SERVICE BULLETIN No. Harmony LSA-044a

SAFETY ALERT

- 1. CONCERNING:** All Harmony LSA aircraft up to S/N 2025 2307 inclusive.
- 2. REASON:** Foot control pedal assembly without a weld reinforcement on countershaft may have been installed in some of the Harmony LSA aircraft.

Fig. 1 Locations of pedal assembly welded reinforcements

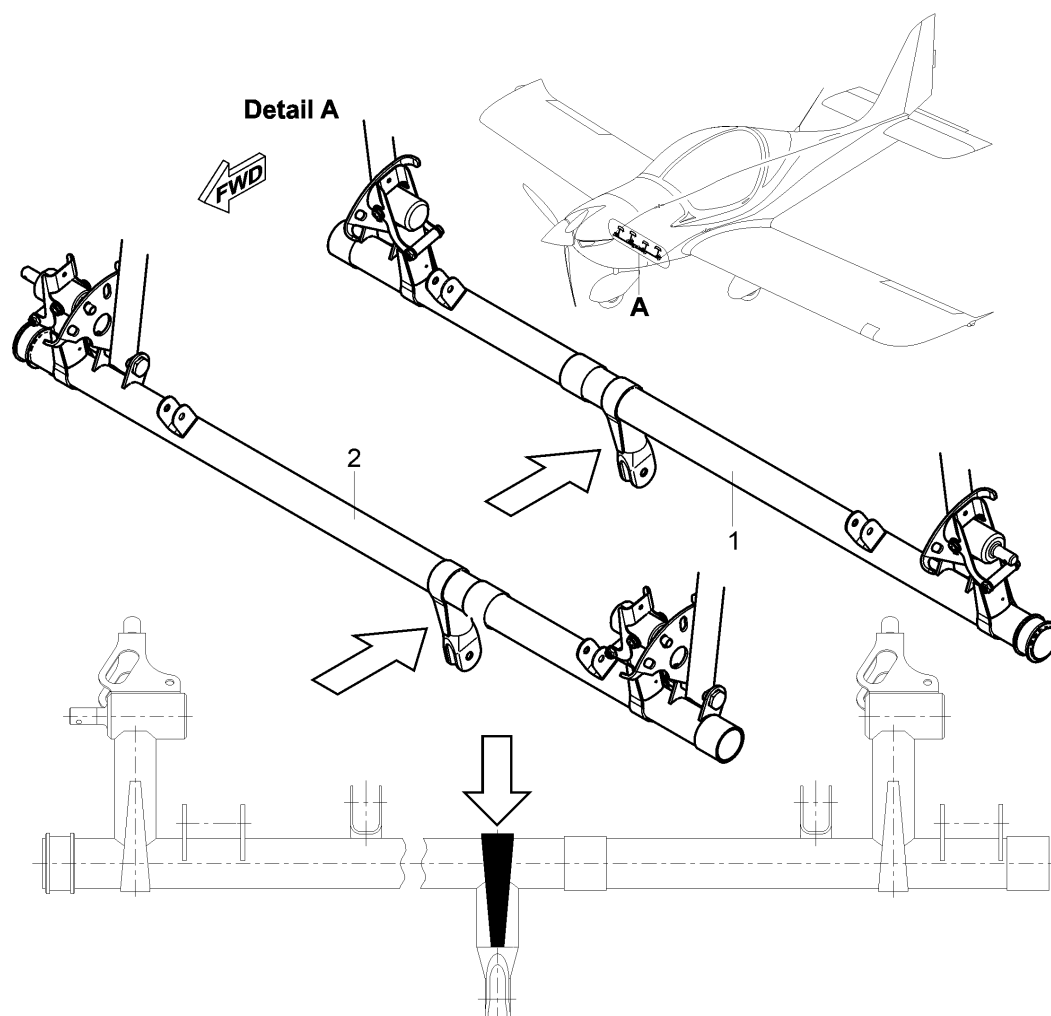
- 3.1.1 Examine whether both foot pedal control assemblies (P/N S4 72-01 01/02 or S4 70-02 01/02, if installed) include the weld reinforcement on the welded connection of countershaft tube (1, 2, Fig. 1) and lever. See Fig. 1 and Fig. 2 for welded reinforcement locations.
- 3.1.2 If the weld reinforcements are missing, take a photo of affected part(s) and report the inspection results to the manufacturer by submitting an Aircraft Occurrence Technical Report, including the photos of the affected part(s).
- 3.1.3 If the weld reinforcements are missing, replace the original countershafts of the foot control pedal assembly with the new countershafts with the weld reinforcement (P/N S4 72-01 01/02 or S4 70-02 01/02) in accordance with Work procedure para. 3.2 and 3.3.

2. If the weld reinforcement is missing, examine the welded connection of the countershaft tube and the lever for cracks.
 3. If the weld reinforcement is missing, replace the original countershaft (P/N S4 72-01 01/02 or S4 70-02 01/02, if installed) with the new countershaft with the weld reinforcement, in accordance with the work procedure of this bulletin.

Fig. 2 (a+b) Detail of Countershaft Left with/without the weld reinforcement

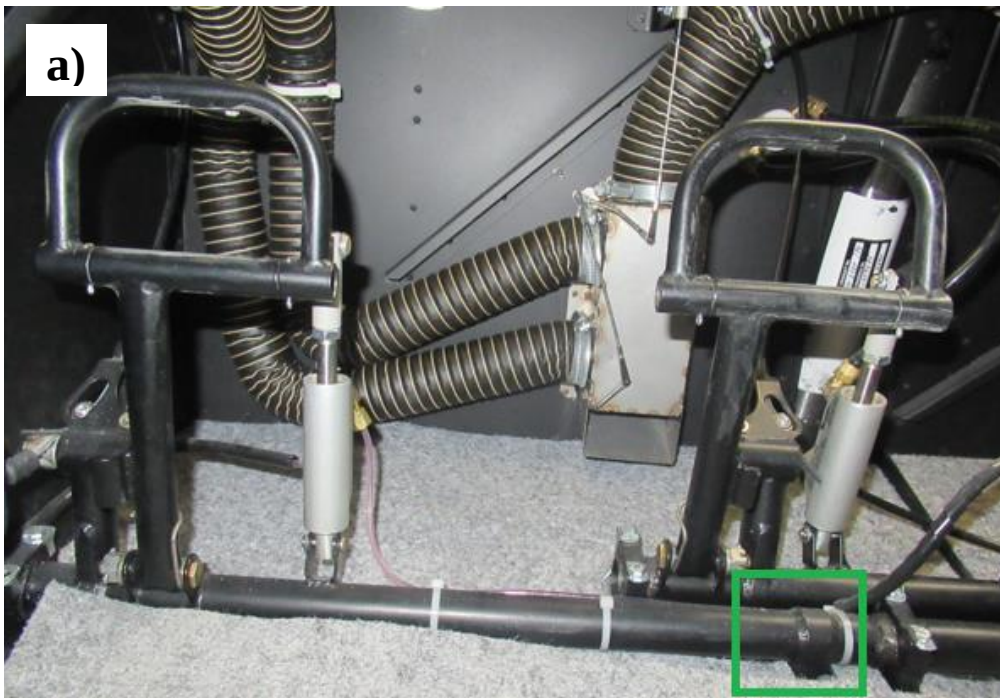
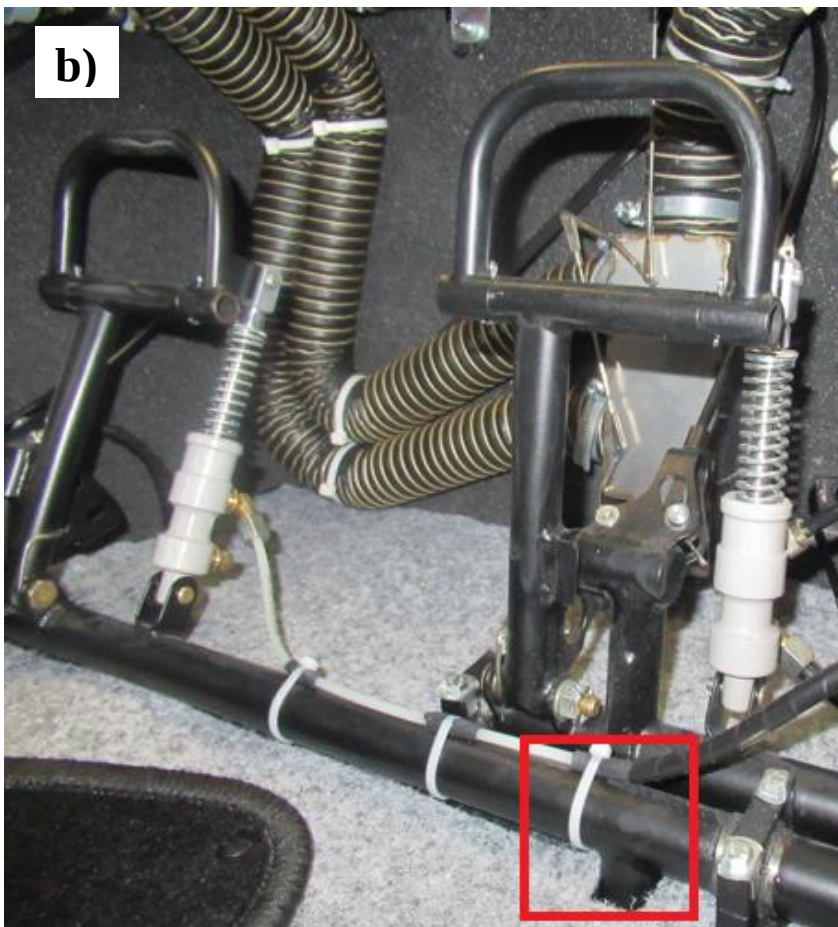
a) Countershaft tube and lever welded connection with the weld reinforcement (green square)

b) Countershaft tube and lever welded connection without the weld reinforcement (red square)
